**HIGHLINE VILLAGE 4 APARTMENTS
 SITE PLAN
 LOT 1, BLOCK 1 HIGHLINE VILLAGE 4,
 CITY OF AURORA, COUNTY OF ADAMS, STATE OF COLORADO
 3.726 ACRES**

2nd Review
 Aurora Water
 Jennifer Wynn
 jwynn@auroragov.org

**Highline Village 4
 Apartments
 Site Plan**

1 GRADING PLAN 2 OF 2
 SCALE: 1"=20'

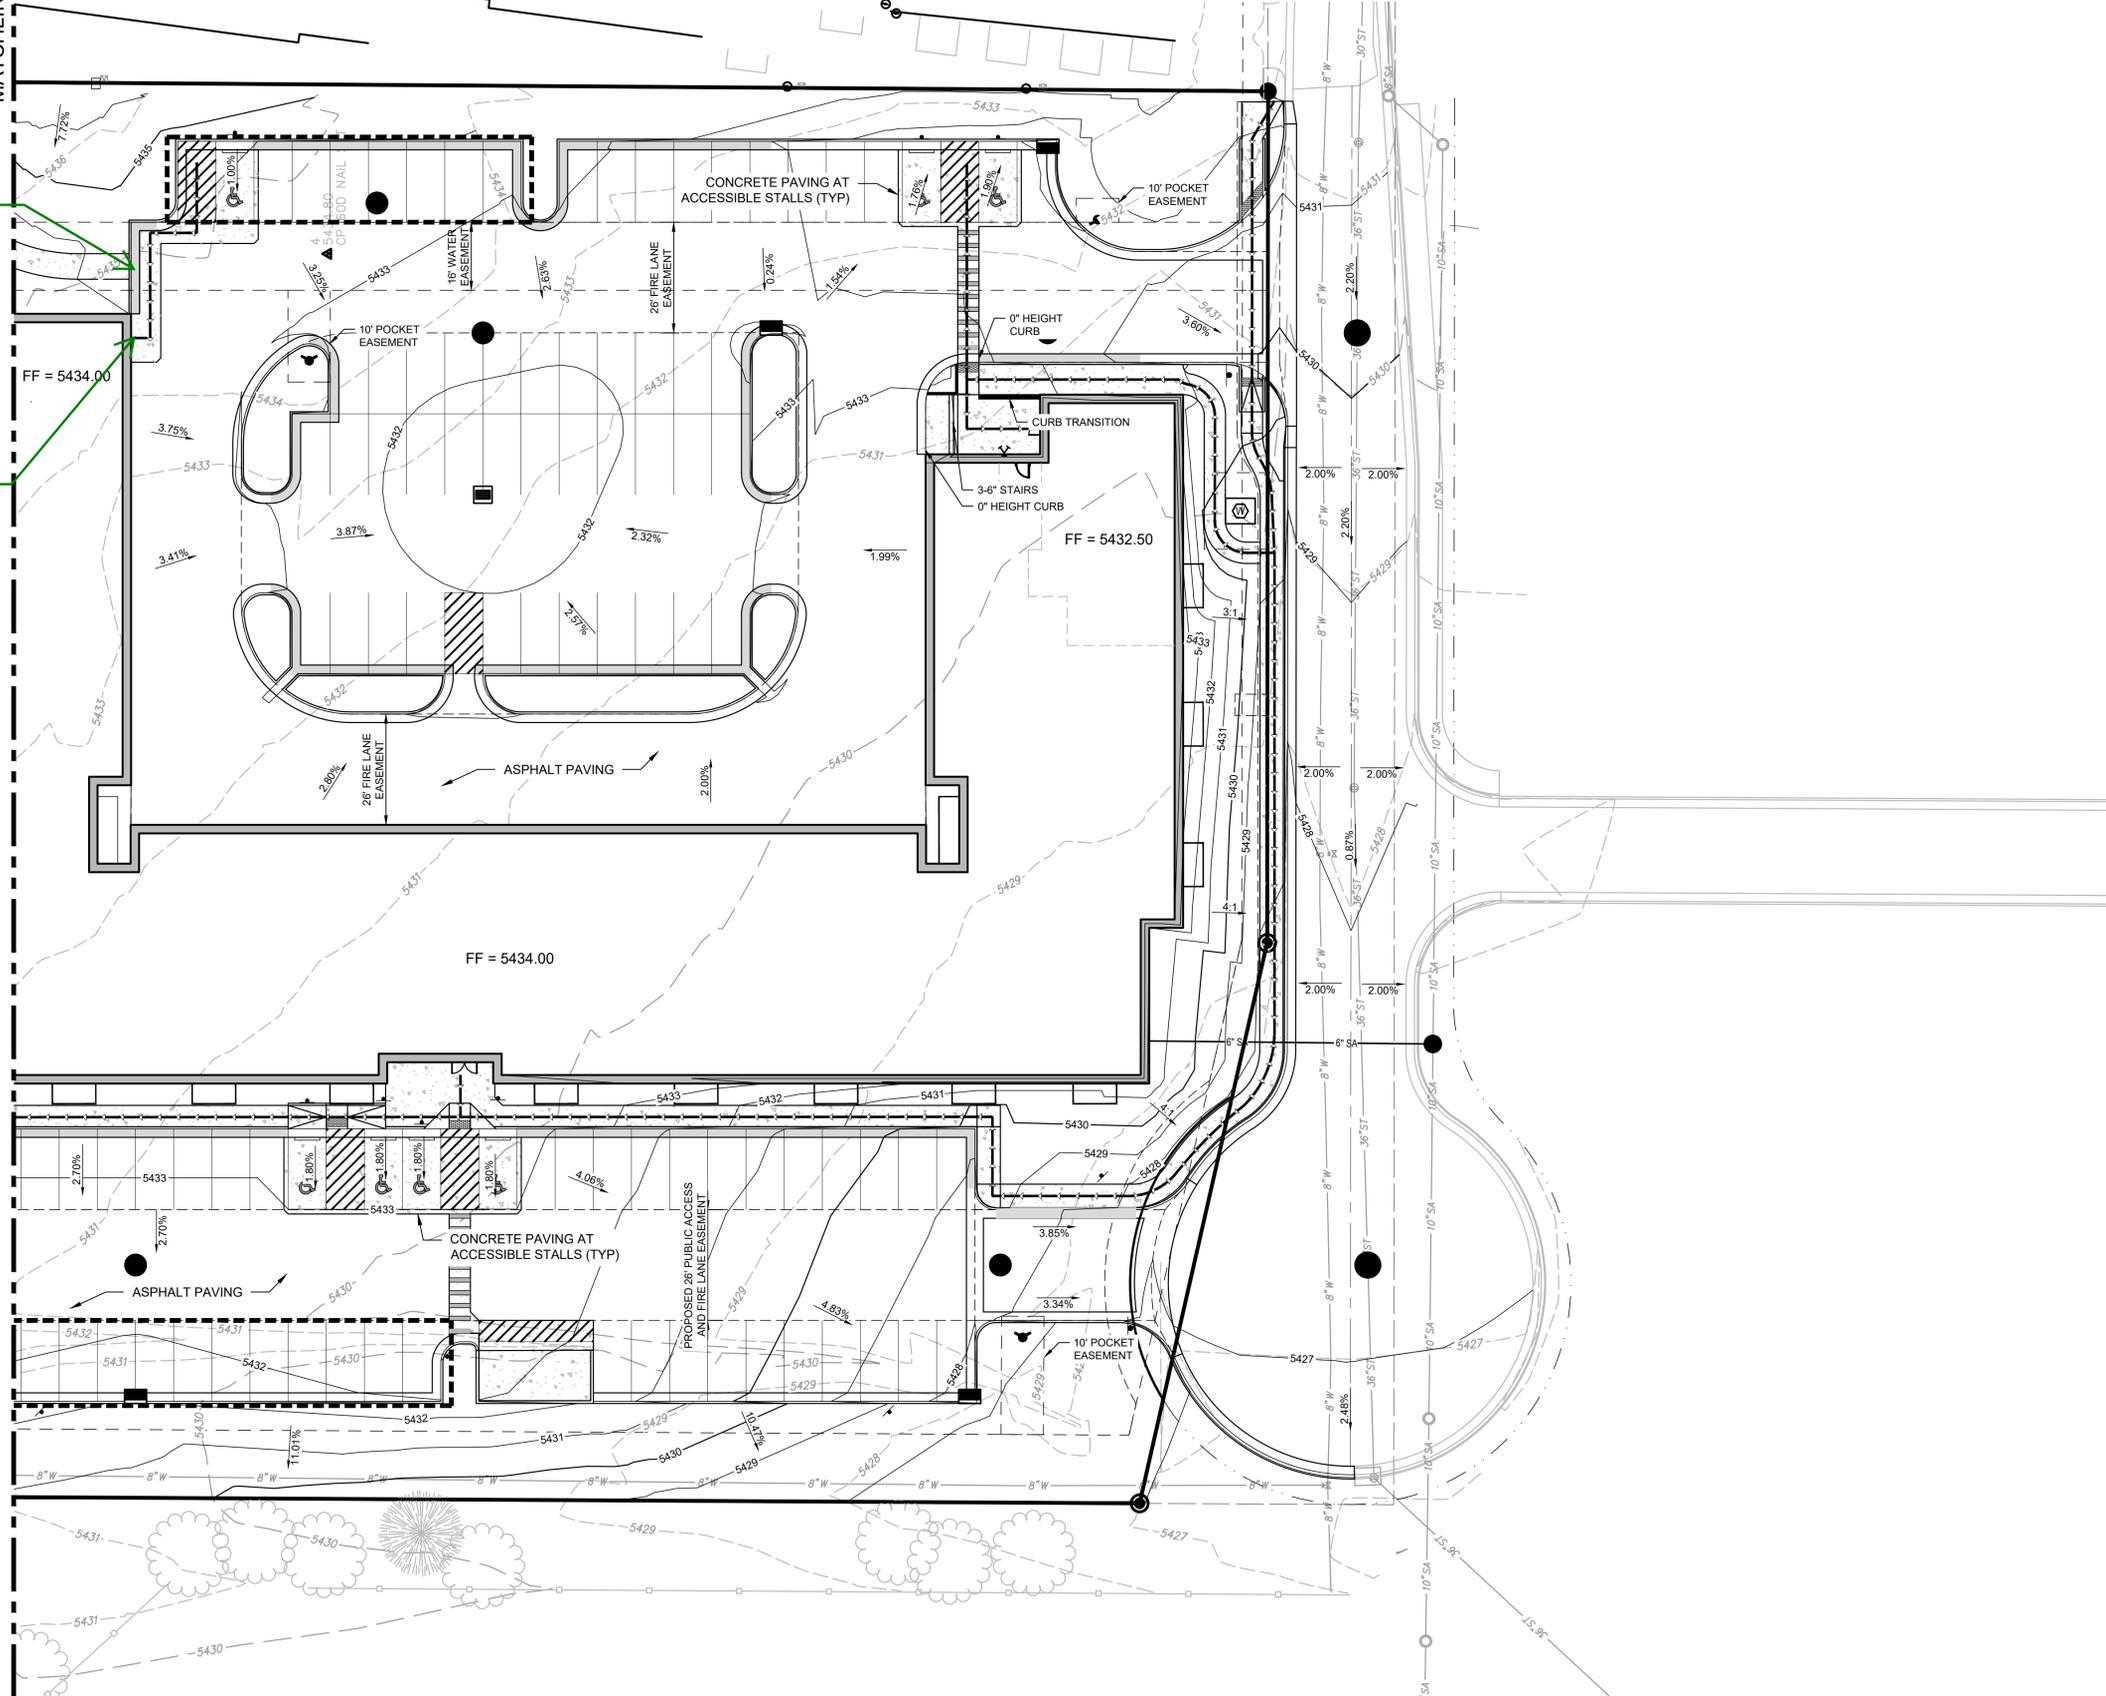
Is the sidewalk accessible from the parking lot?

Is there an entrance? if yes, please show the entrance.

Revised

Revised

**TREE MITIGATION
PLAN**

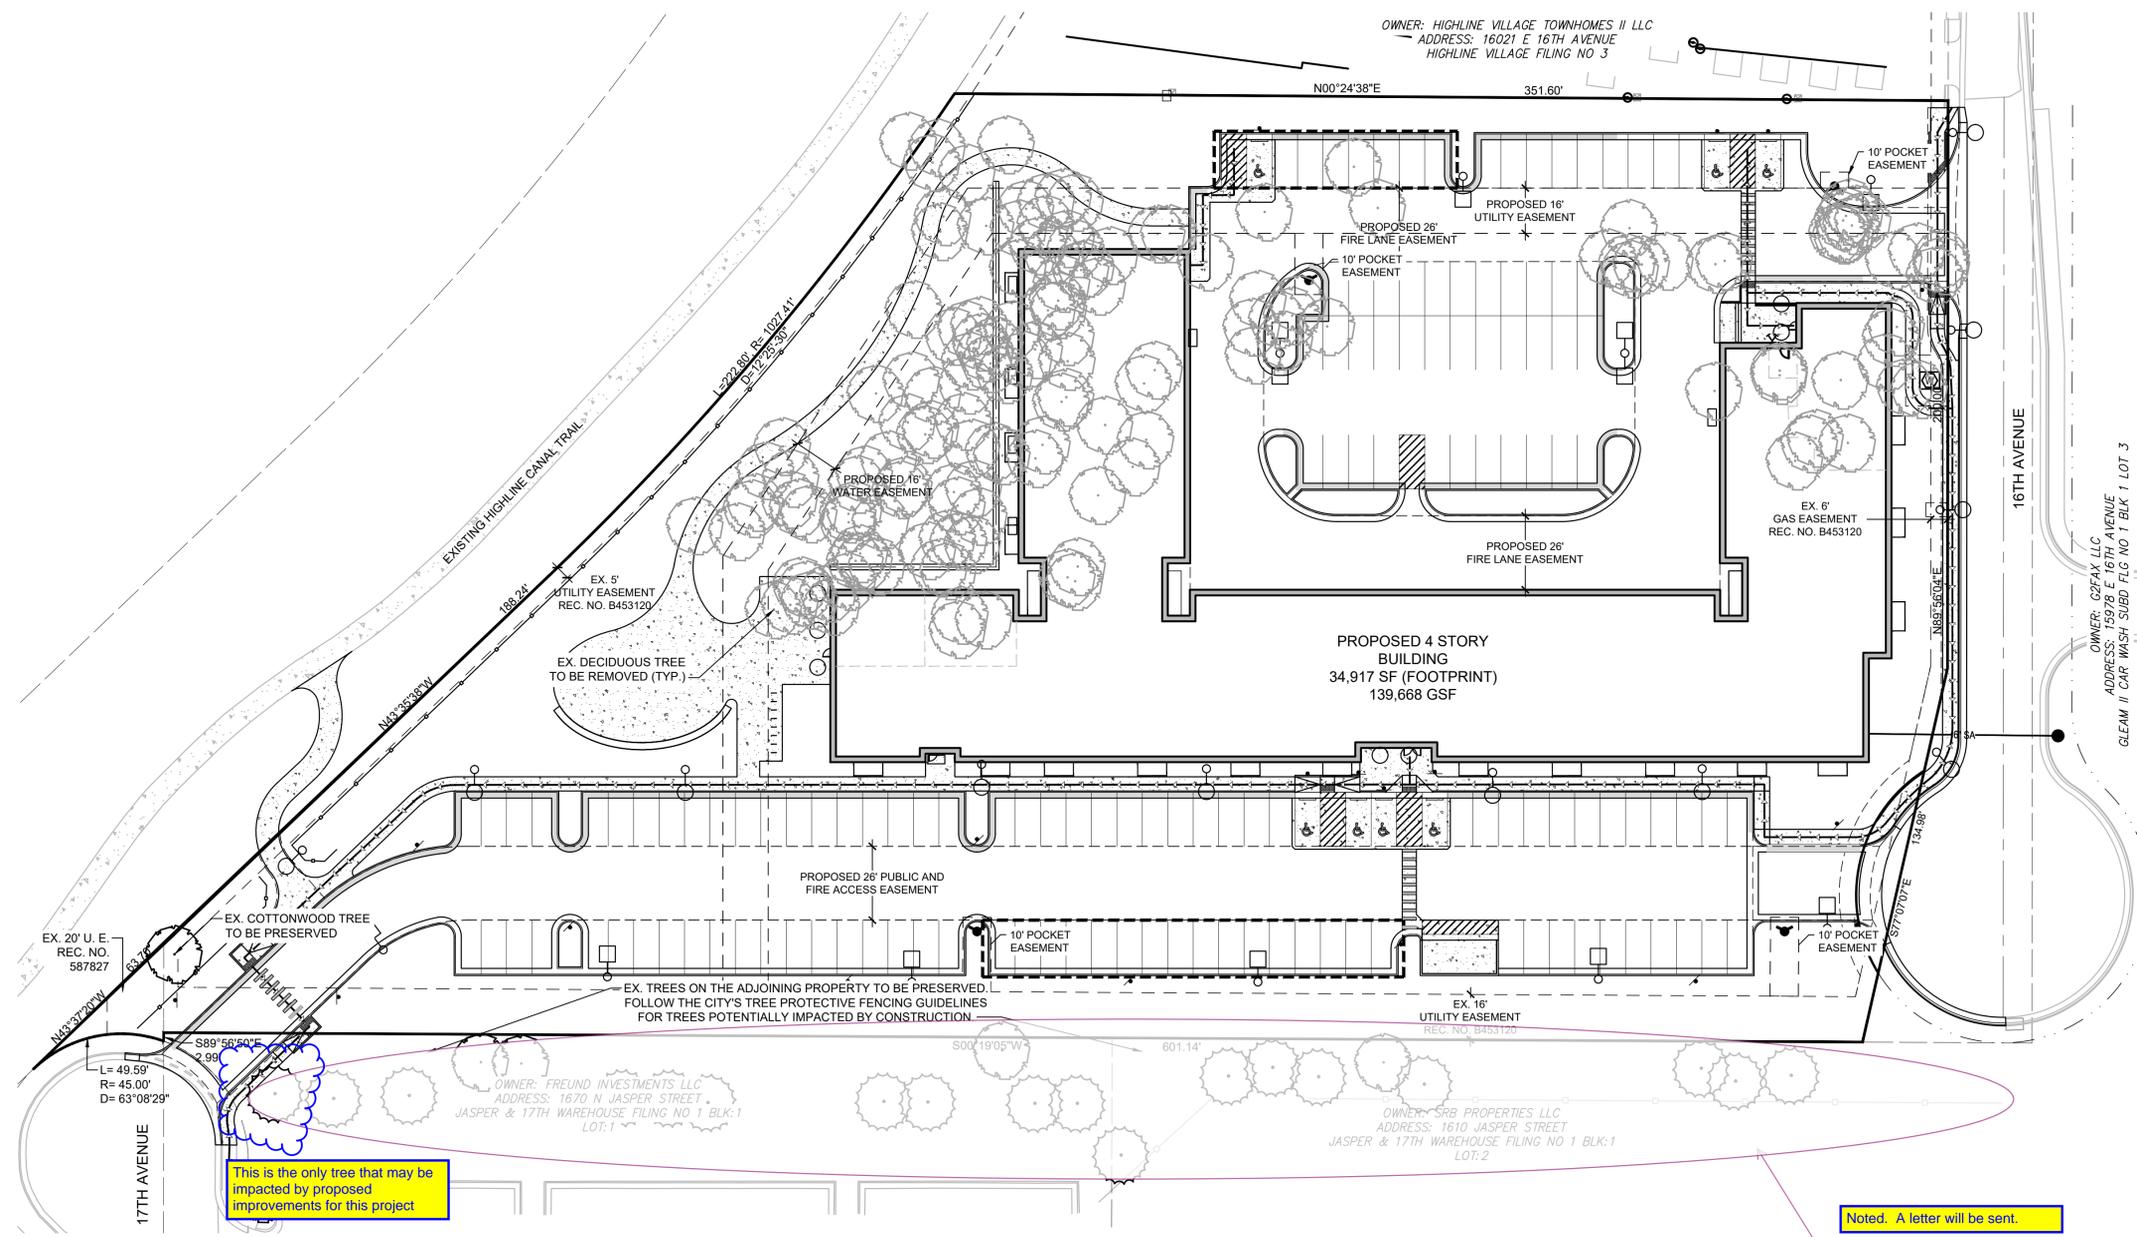
The adjacent property located to the west has several trees, which will most likely be impacted by this development. We are requesting that you send a certified letter to the adjacent property indicating the methods used to protect these trees, as well as remedies as a result of potential damaged incurred from the development. Please provide the City of Aurora a copy of this letter including the date sent and received

Aurora Forestry cannot approve plan until tree mitigation has been paid.

1 PROPOSED PHOTOMETRIC PLAN
 SCALE: 1" = 30'-0"

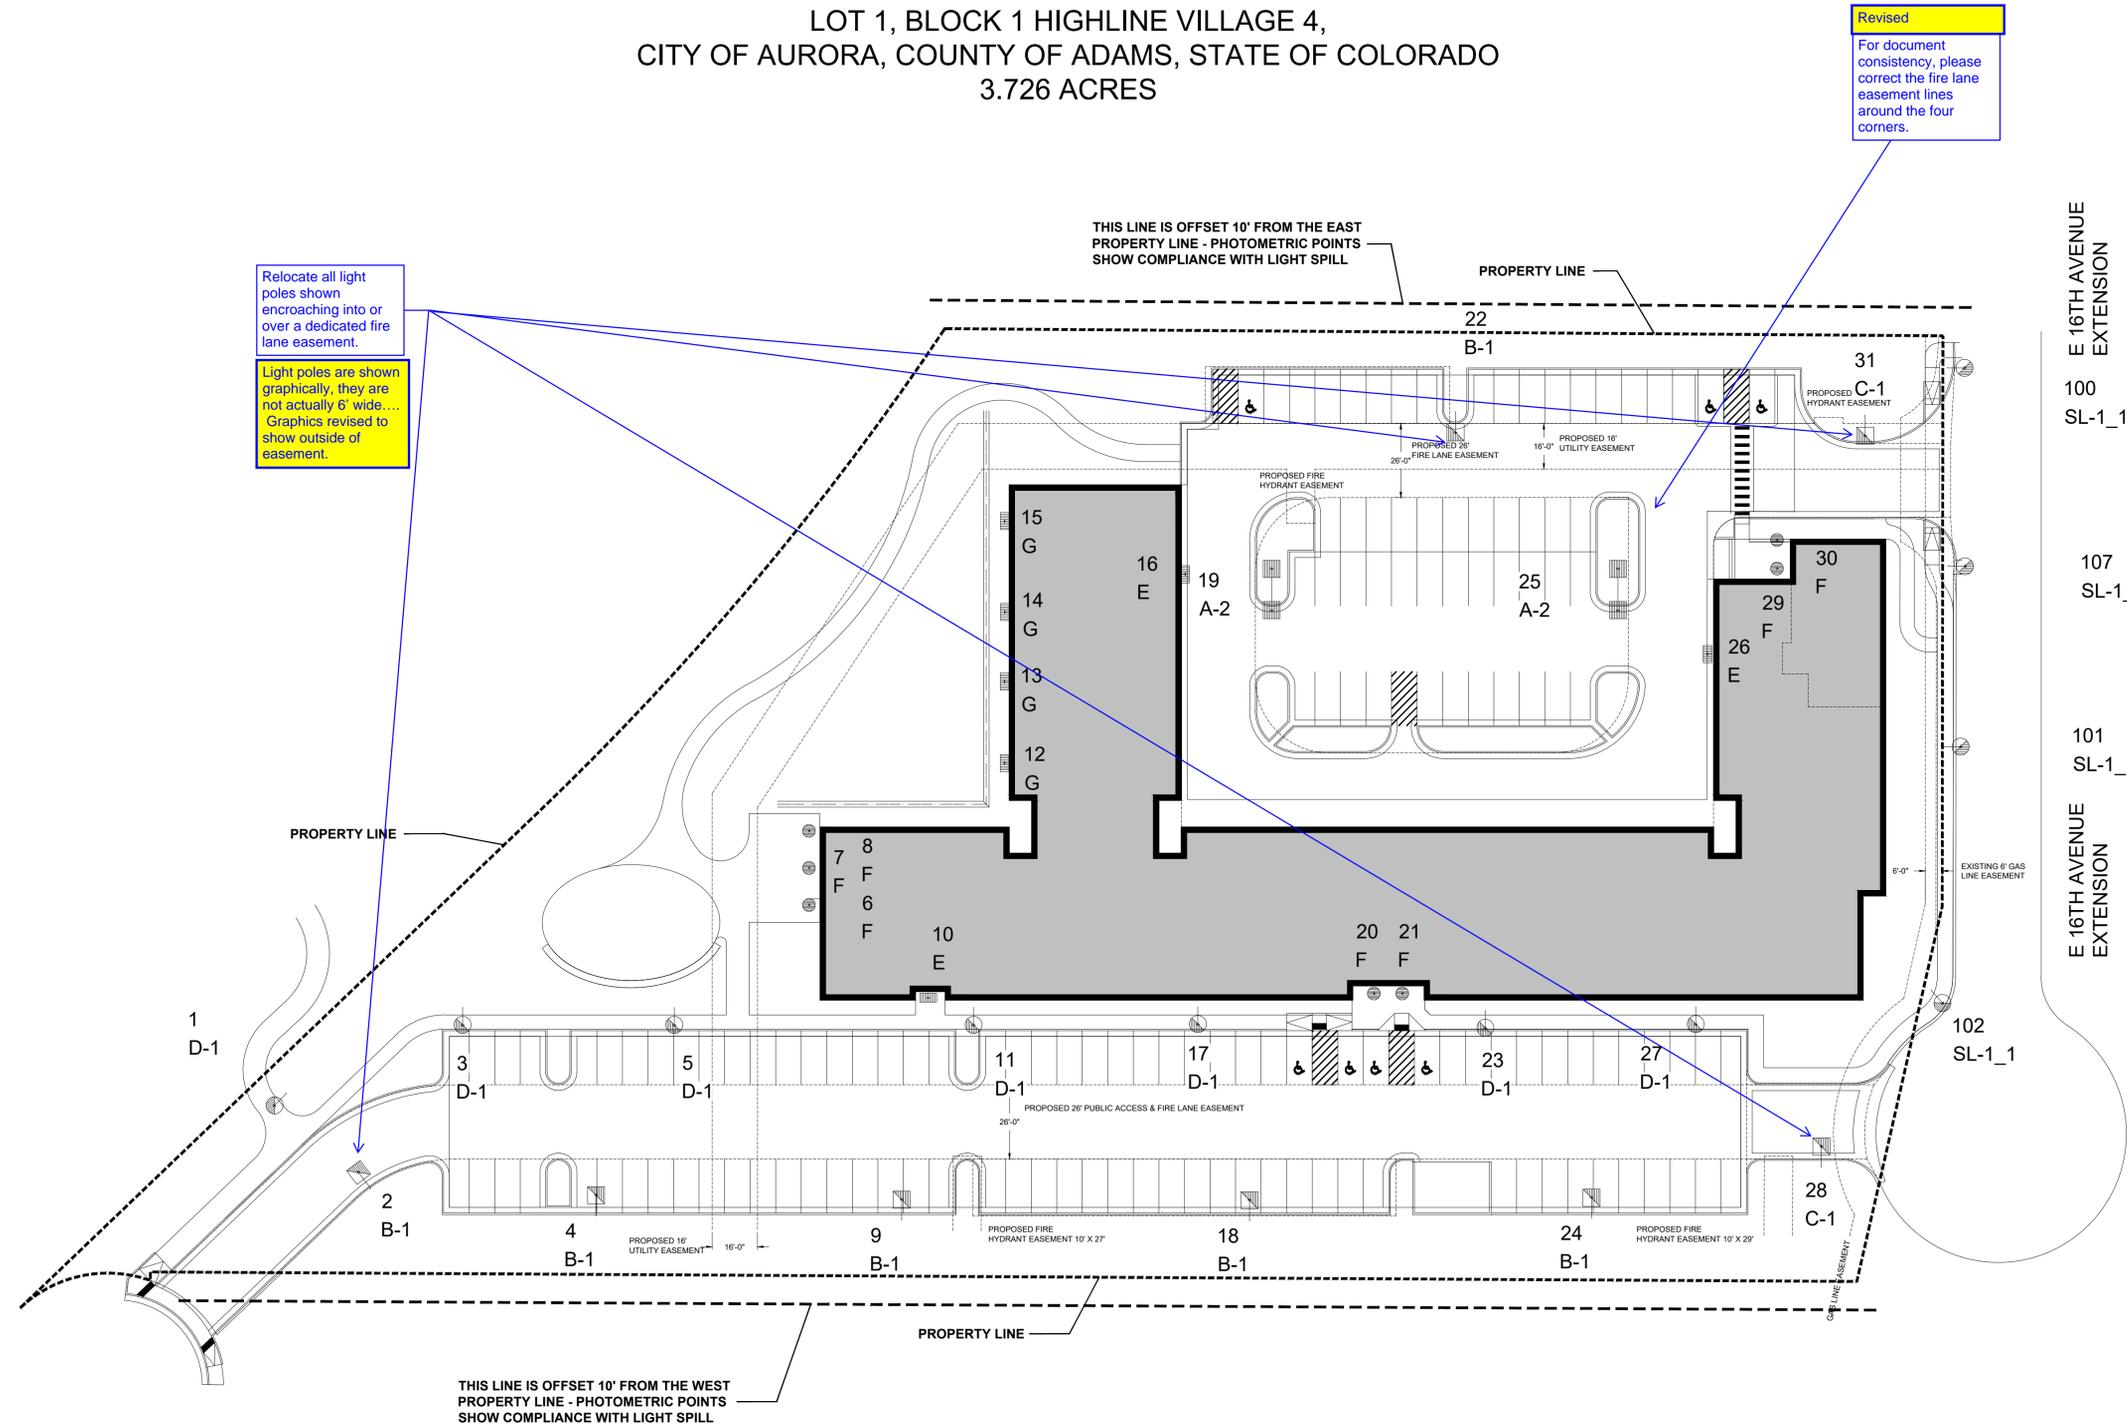
Revised Show and label the paths of exit discharge on photometric sheet. See notes below.

Please remove from this site plan. It will be reviewed at the civil plan stage.
 Revised
